**SUBMISSION IN RESPONSE TO THE ENVIRONMENTAL IMPACT STATEMENT (EIS) OF THE
HUMELINK PROJECT (APPLICATION NO. SSI-36656827)**

I submit this response to the HumeLink Environmental Impact Statement report as tabled by the proponent, TransGrid.

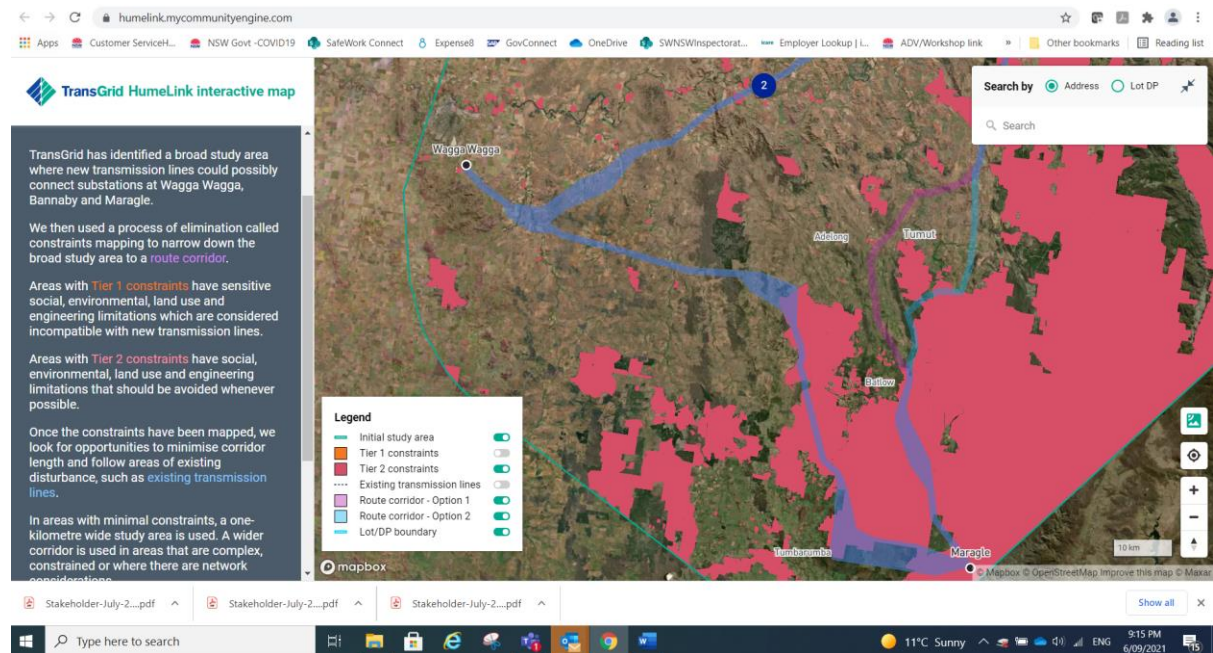
Several areas were originally traversing low environmental impact areas, and now they are building transmission through high risk *Tier two* areas. Appendix A outlines images showing the changing route over two periods of time, both of which traverse through Tier Two areas and additional concern these have now been removed from the proponent's website and not viewable. The proponent has also failed to acknowledge the impact to these constraint areas that can be eliminated by placing the transmission underground, which is a feasible option.

IMAGE 1: Showing original route avoiding Tier 1 and 2 constraints out of Maragle, but then through dense forestry (Tier 2 areas). The original route through to Wagga Wagga avoided Tier two areas and was a shorter route. **It remains unclear how the new overhead transmission re-routes through dense forestry and farming land is appropriate given the significance of Tier two constraints when undergrounding (particularly for these areas) will help reduce bushfire risk and help save lives while fighting fires.**

IMAGE 2: Showing map screenshot taken approximately June 2022, showing more line within Tier 2 constraints

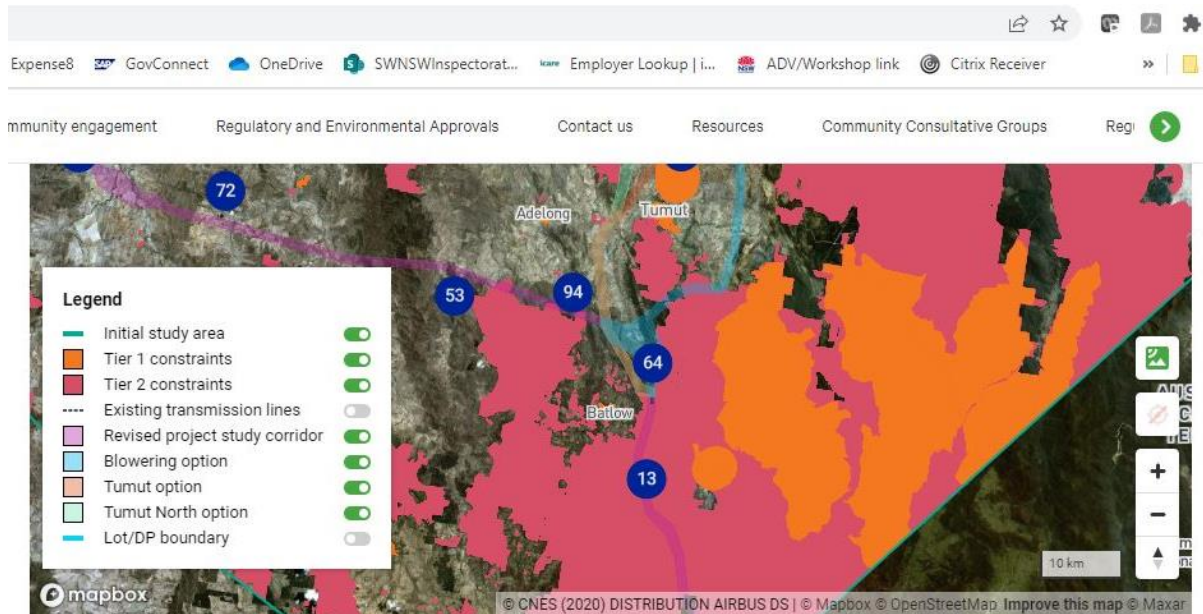
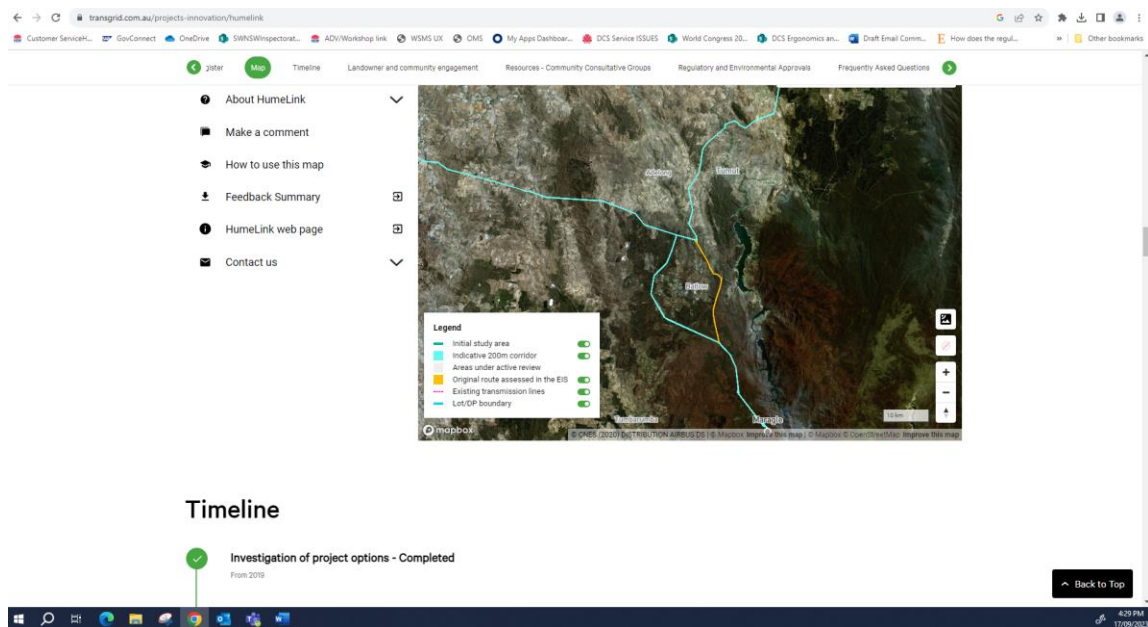
IMAGE 3: Map screenshot as of 17 September 2023. **Also shows legends do not work and no longer displaying Tier 1 and 2 areas of concern.** (Source: TransGrid <https://www.transgrid.com.au/projects-innovation/humelink> accessed 17 September 2023)
